RE: **NSM Williams TI**  
**103 N Ivy – Portland, Oregon**  
**Permit # 13-199915-DFS-02-CO**  
**Structural Plan Check Response**

### STRUCTURAL CHECKSHEET

Application # : **12-199915-DFS-02-CO**  
Review Date : **May 15, 2013**

Description of Work: DFS - ACOUSTICAL CEILING

Sheet No: C-2

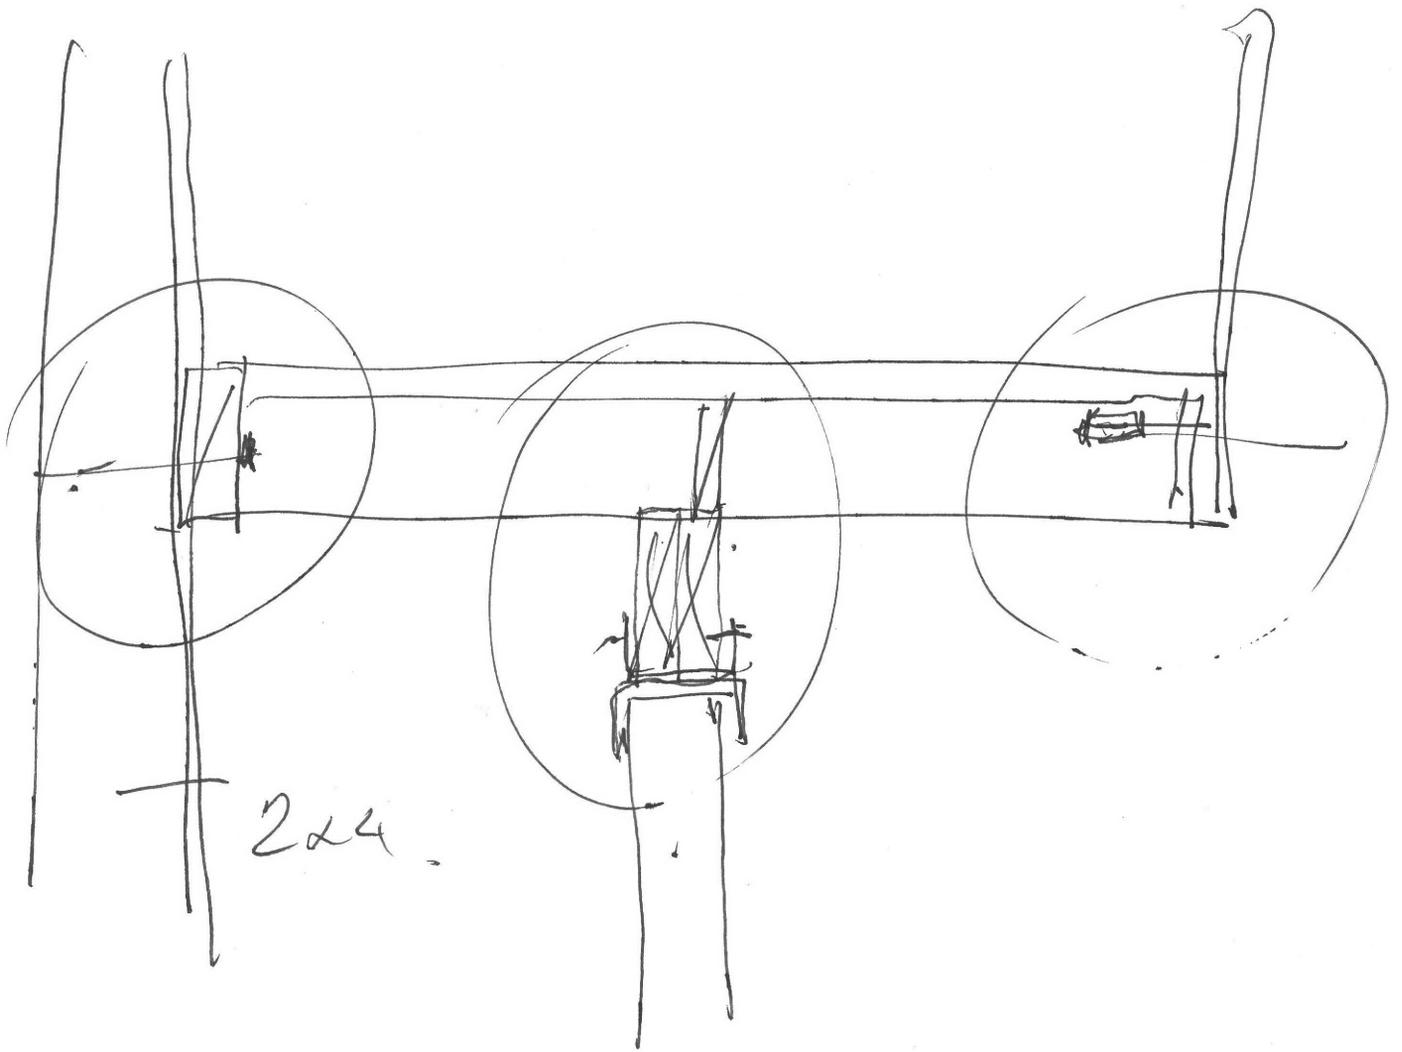
Item #	Location on plans	Code Section	Clarification / Correction Required
1.		OSSC 110.3.9	Please specify if any special inspection on the project.
2	Dtl12 , 13		Note on details: " Provide support from the structure." Please provide support from the structure. Provide calcs for the support as necessary.
3.			
4.			
5.			
6.			
7.			
8.			
9.			
10.

$$F_p = 0.28 W_p = 0.28 \times 4 \text{ xst} \times 144 \text{ ft}^2 = 161 \text{ \#}$$

$$T_{max} = (161 \text{ \#} \times 1.41) / 2 \text{ WIRES} = 114 \text{ \#}$$

$$12 \text{ g9 ALLOW (SNT C-1)} = 158 \text{ \#} > 114 \text{ \#} \quad \underline{OK}$$

$$\text{CONNECTION ALLOW (SNT C-1)} = 117 \text{ \#} > 114 \text{ \#} \quad \underline{OK}$$

(A) #12 SPLAY WIRES  
AT 45° FROM GRID  
ON 12x12 SPACING,  
SAME CONNECTORS  
AS VERTICAL WIRES

**12. VERTICAL HANGER WIRE ATTACHMENT**  
 SCALE: 3/4"=1'-0"

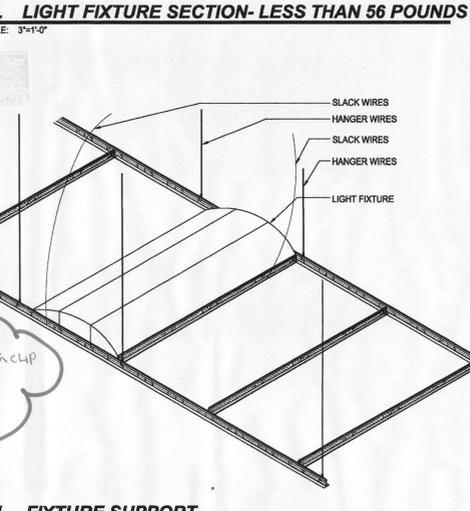
**ITEM 2 – *Attachment to structure.***

**Response:** Refer to attached calculations C-1 and C-2. As installed condition is structurally acceptable. *A callout of the connector has been added to referenced details. These items were reviewed on site during our structural observation of May 9, 2013.*

**Response:** Refer to attached calculations C-1 and C-2. As installed condition is structurally acceptable.
